Public Service of New Hampshire

NYN-88078

Subject: Response to Request for Additional Information - ISI Program

Enclosure to NYN-88078

# ATTACHMENT D

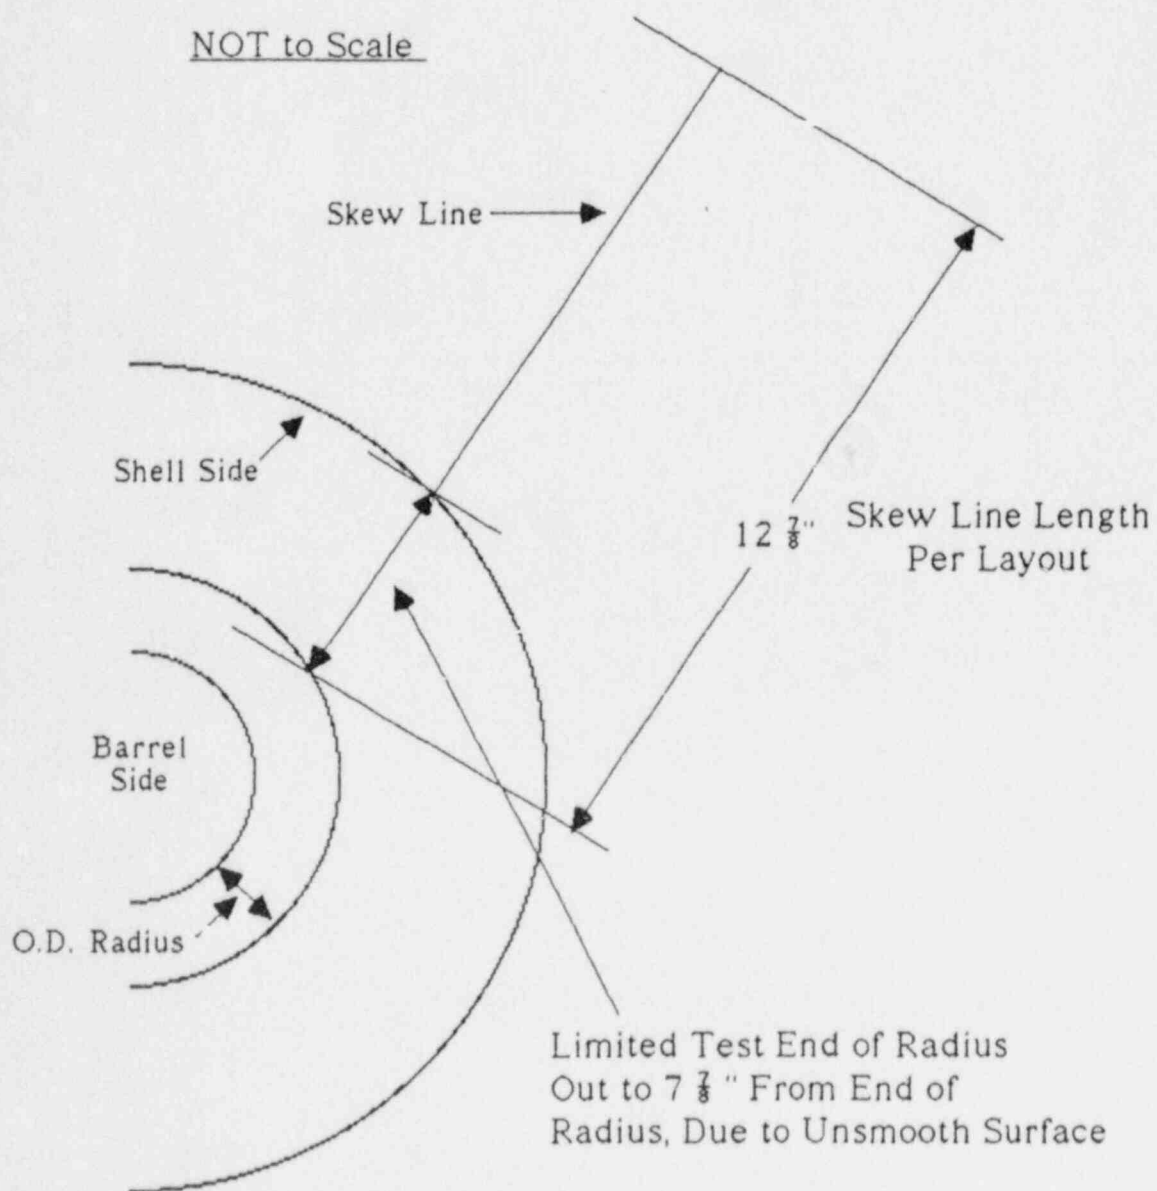
Request for Relief IR-4: With regard to the following Steam Generator nozzles, provide further information (i.e. drawing or sketches) showing the typical configuration of the nozzle inner radius sections and/or surface conditions which prohibit performing 100% of the Code-required volumetric examinations.

Nozzle ID

1-RC-E-11A-16IR  
1-RC-E-11B-16IR  
1-RC-E-11C-16IR  
1-RC-E-11D-16IR  
1-RC-E-11C-11IR

Attachment D to this enclosure is a drawing of a portion of the Steam Generator vessel showing the steam outlet nozzle (i.e. 16IR). As shown, the configuration of this nozzle makes the inner radius ultrasonic examination impractical.

Nozzle inner radius on 1-RC-E-11C-11IR does not represent a configuration problem but rather a surface condition. Attachment D also shows the examination set-up utilizing the required 70 degree skew angle in which surface roughness prohibited examination.

ATTACHMENT E  
TYPICAL MAIN STEAM  
6" BRANCH SWEEP-O-LET

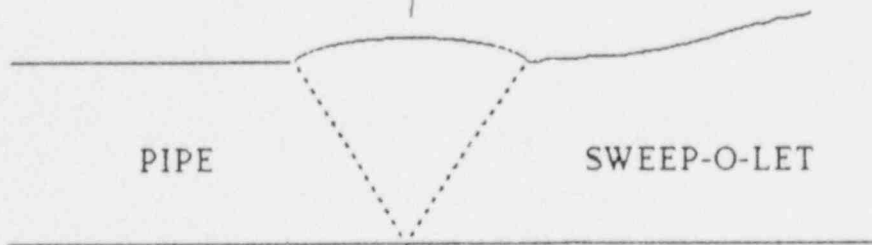
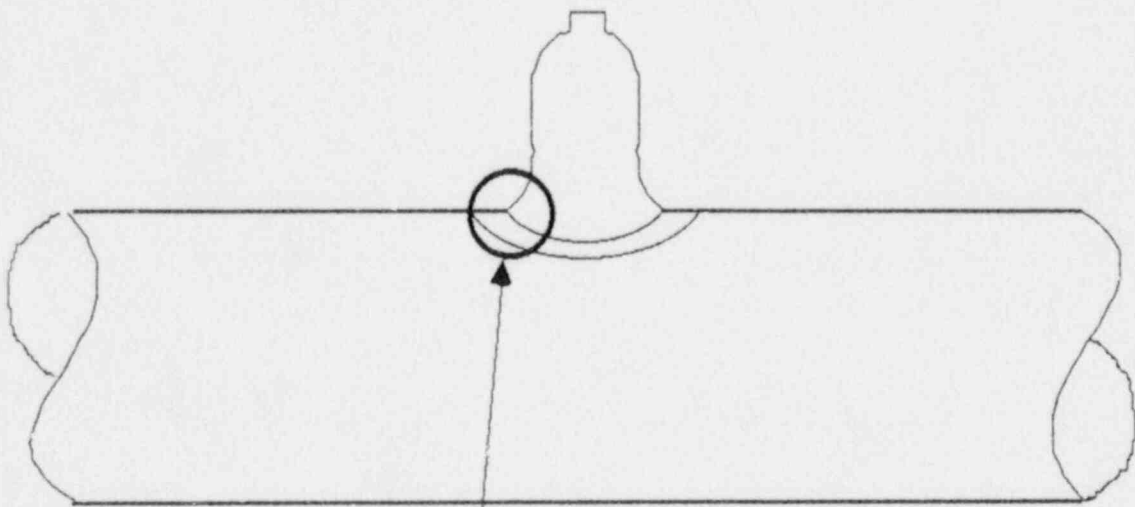
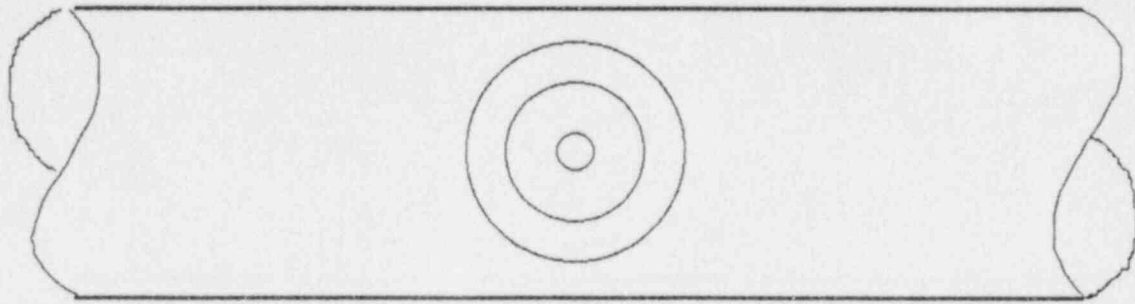
Request for Relief IR-5: Relief is requested from performing a 100% volumetric examination on seven 6-inch Code Class 2 branch connection welds due to permanent obstructions that restrict volumetric examinations. It is noted that neither 83S83, Examination Category C-F, Item C5.30, nor the alternative rules of Code Case N-408, Examination Category C-F-2, Item C5.81, require volumetric examinations of these branch connections. Based on the above, provide additional information with regards to why relief is requested for these welds.

It is correct that volumetric examination is not required for branch connections of this size under the stated rules. The Seabrook FSAR commits to augmented ISI of main steam and feedwater piping which consists of 100% examination of the longitudinal and circumferential welds. As depicted in Attachment E to this enclosure, these connections on the main steam header are not the normal 6" tee fitting but rather a sweep-o-let. Since these fittings represent a large weld area on the main header, a conservative judgement was made during PSI to include these welds under Examination Category C5.81.

Our relief is requesting variance due to geometric configuration, permanent obstructions and/or structural interferences on 100% examination for these welds which are being conservatively examined under C5.81.
